A. Power Trim Limit Switch and Indicator Sender Operation on MerCruiser 120-thru-233

B. Trim Tab Length on MerCruiser 120-thru-233

A. POWER TRIM LIMIT SWITCH and INDICATOR SENDER OPERATION on MERCRUISER 120-thru-233

Trim Indicator Sender B-63115A12 (Single Station) and B-63115A13 (Dual Station)

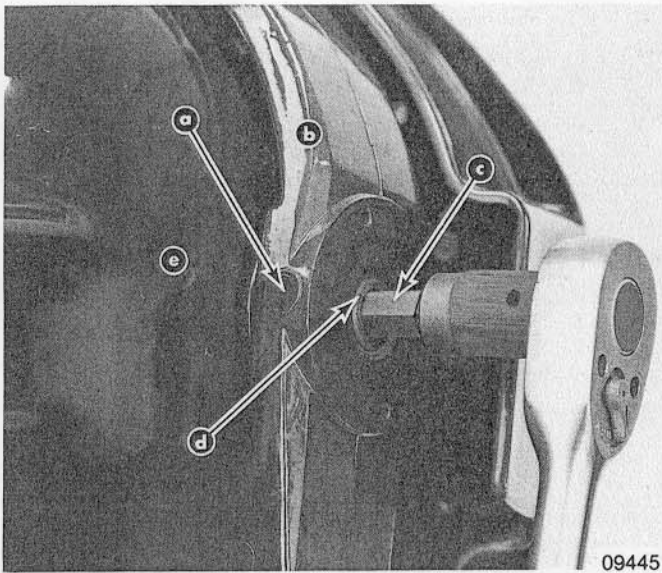
1. Connect continuity meter to sender leads.
2. Meter should indicate an even movement between zero and approximately 160 ohms for single station sender and between zero and approximately 80 ohms for dual station sender. Further rotation will carry resistance value beyond 160 ohms (this is normal). If erratic or no needle movement is noted, remove the sender from the gimbal ring and operate manually. If meter movement still is erratic or has no meter movement, replace and adjust a new sender. Also be sure that mechanical check, below, is satisfactory.

Figure 1. Removing Hinge Pin; Location for Grease Fitting Hole

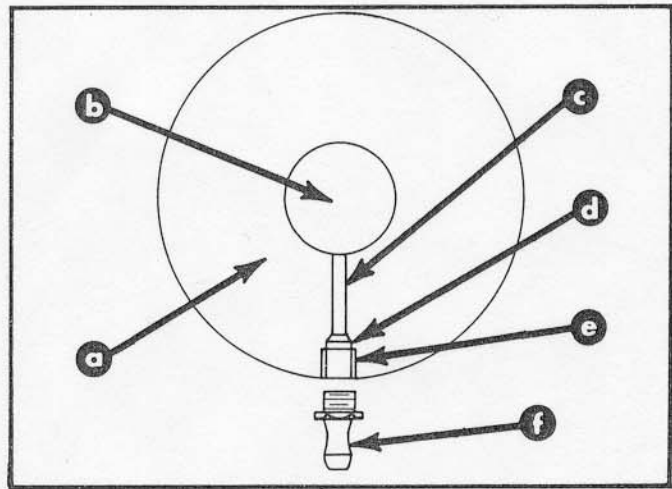
1. Remove trim limit switch or trim sender from gimbal ring.
2. Trim drive unit and observe the hinge pin. Hinge pin should move with the bell housing assembly. If the hinge pin does not move, complete the following:
 - a. Use heat directly on hinge pin to aid in removal from bell housing and gimbal ring (one each side, Figure 1)
 - b. Following drilling instructions in Figure 2 to install grease fittings (C-22-74036) in gimbal ring (one each side).
